COMMUNITY PLANNING, DEVELOPMENT & INNOVATION

Development Services Division

Re: West End Homes Annexation, Zoning, and Subdivision 1st Sufficiency Review

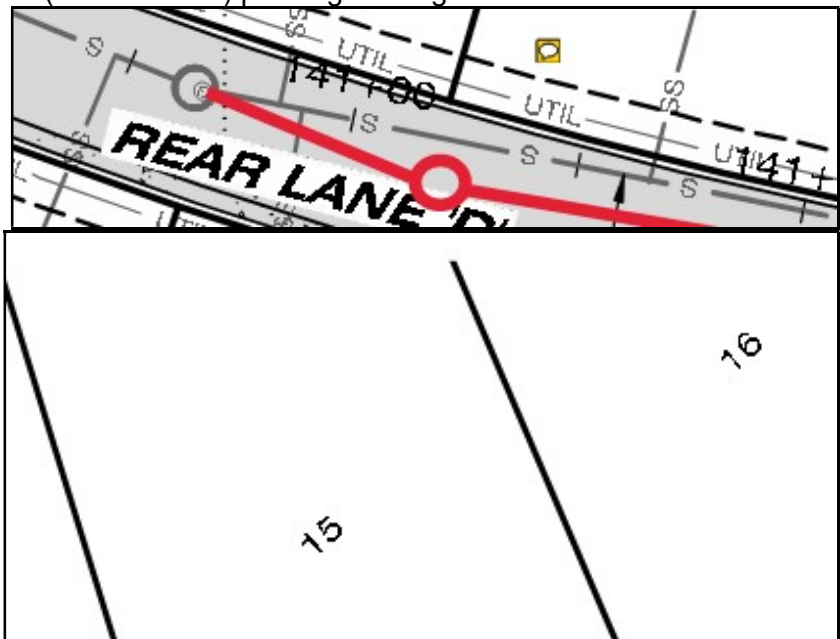
- Engineering: A condition of approval will require OP2 and OP3 to be private utility easements because there are services running through the parks. Sheet 4 of the Utility Construction Plans – Services for lots not fronting utility mains need service line easements, including through common areas (Article 3, Section 3-060.1).

- A condition of approval will require 1' No Access Strip along the front of all alley loaded lots (all streets) per Article 3, Section 3-020.10.D "motor vehicle access to the lots and off-street parking must be from the rear yard when an alley exists or is planned".

- Engineering stated "Possible Condition or show on preliminary plat – Provide 8' PAE on north parcels prior to final plat of Phase I. Verify the dimension and leaders on the plat provided." Reach out to Steve Reichert for more context/explanation.
